Subject: RE: Green Bay Packaging Minor Permit Modification Application (AFIN: 15-00001; Permit 0284-S3N)

RE: Minor Permit Modification Application
Green Bay Packaging Inc., Arkansas Kraft Division Class 3N Landfill
AFIN: 15-00001; Permit: 0284-S3N

MINOR PERMIT MODIFICATION APPLICATION

Green Bay Packaging – Arkansas Kraft Division Class 3N Landfill
Morritlon, Arkansas

EXISTING SITE CONDITIONS

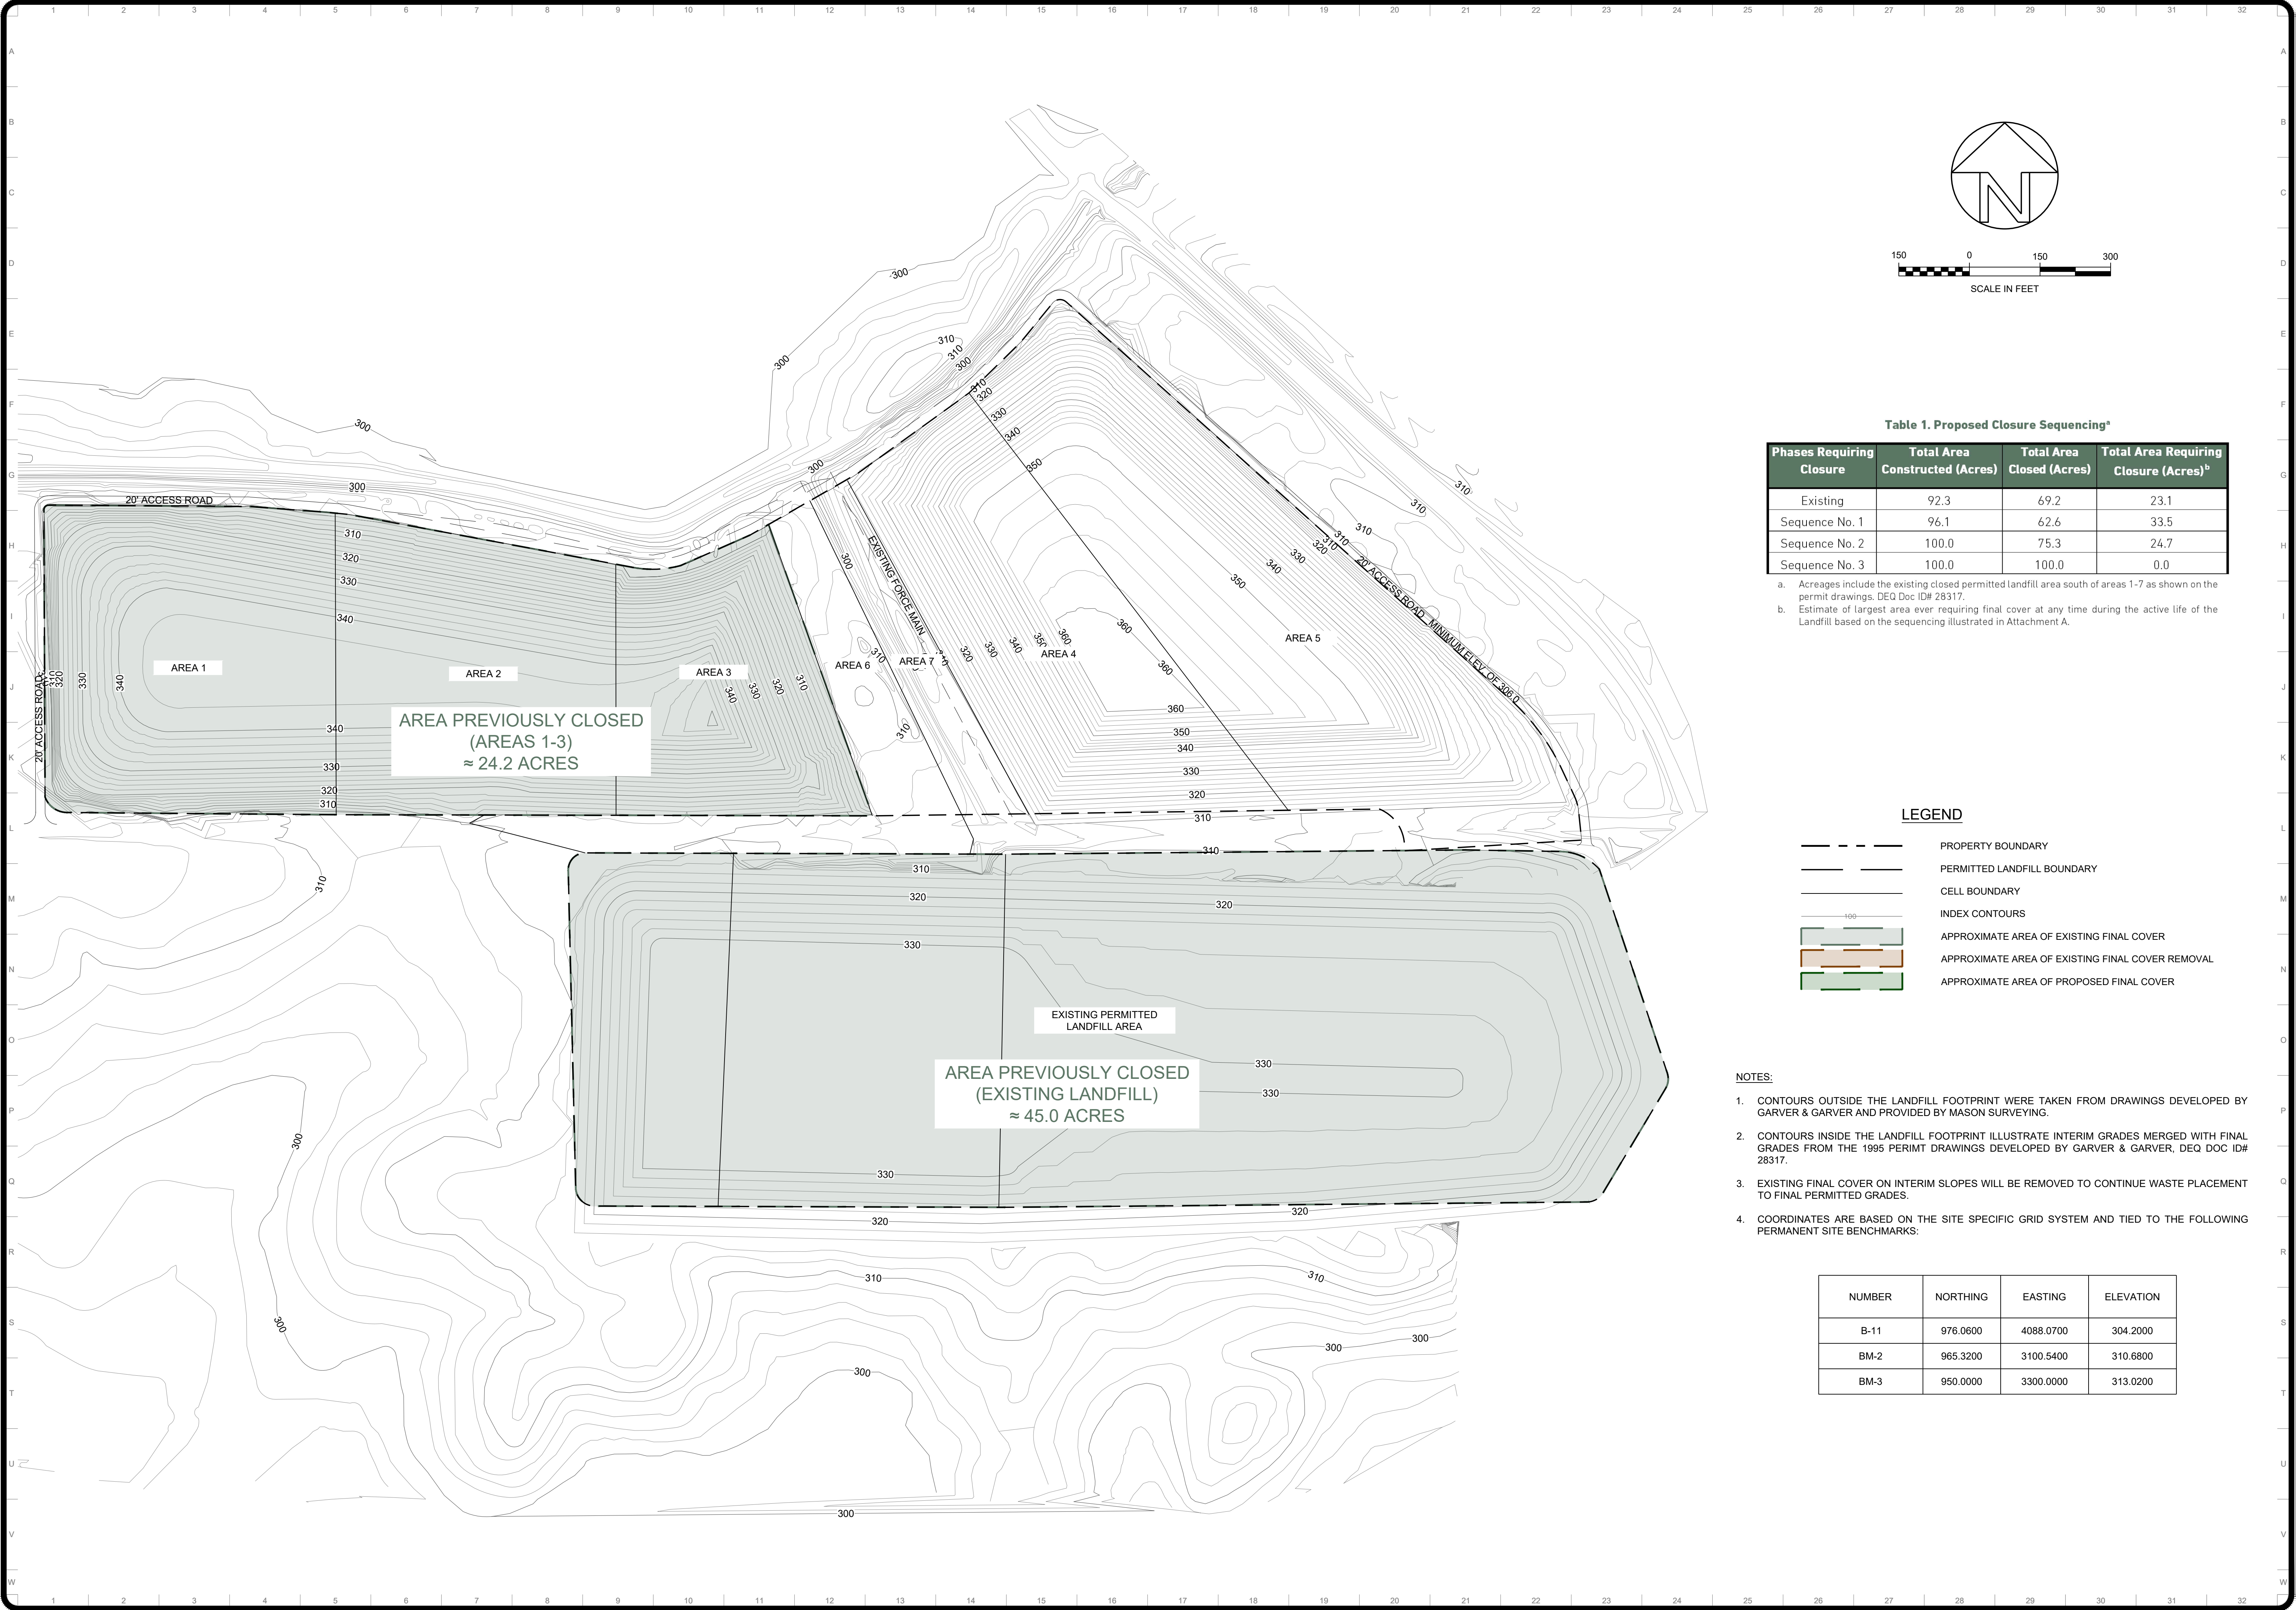
Other *(Specify)* The closure plan will be updated to no longer show
final cover installation over interim slopes. Additionally, existing final cover on interim slopes
will be removed to continue waste placement of final permitted grades.

- PROPERTY BOUNDARY
- PERMITTED LANDFILL BOUNDARY
- CELL BOUNDARY
- INDEX CONTOURS
- APPROXIMATE AREA OF EXISTING FINAL COVER
- APPROXIMATE AREA OF EXISTING FINAL COVER REMOVAL
- APPROXIMATE AREA OF PROPOSED FINAL COVER
